## **SEPTIC SYSTEM:**

APPLICATION FOR INDIVIDUAL SEWAGE DISPOSAL SYSTEM PERMIT

Subject: Percolation Test for Cisco Lundsford - A.P.# 308-231-02

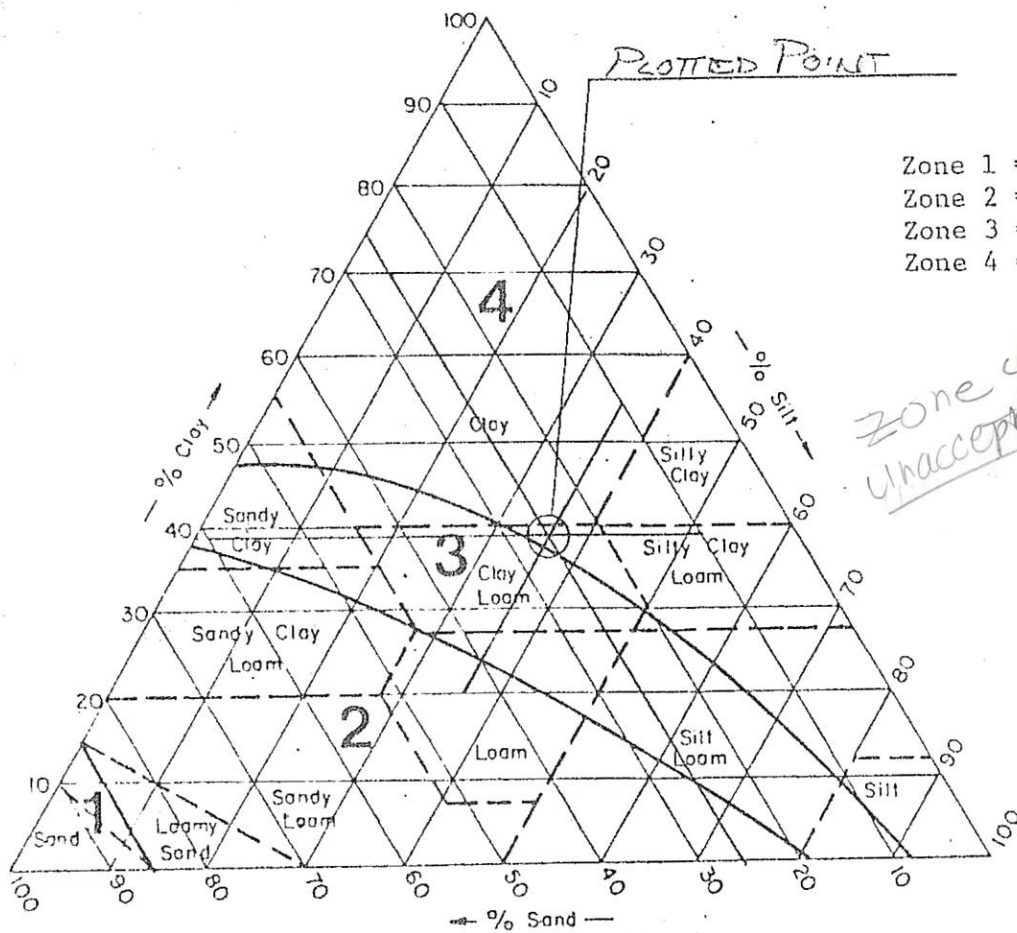
a meeting was held in my office  
to review the percolation test results  
submitted on this parcel - the  
variations from our procedures <sup>were</sup>  
discussed including hole size,  
leaking test, measurement  
method. Also reviewed the  
skewed results on hole #4.  
Reviewed profiles, texture  
analysis and observed  
sample of soil. Clark had  
collected. Discussed type of  
soil and location of  
project. The conclusion  
was that the percolation  
tests were not properly  
conducted and should  
be repeated.

SOILS PERCOLATION TEST DATA

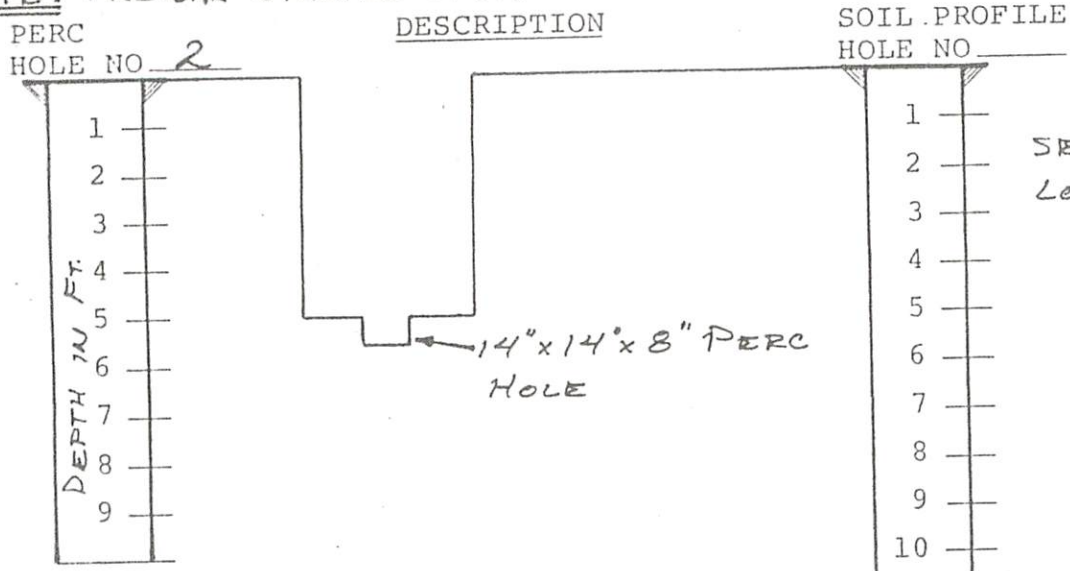
This is very interesting  
why when 8" depth was  
used per note dropped

I wonder how many holes  
8" deep could influence note  
Maybe 8" is not better when  
air soil interface is near  
testing level
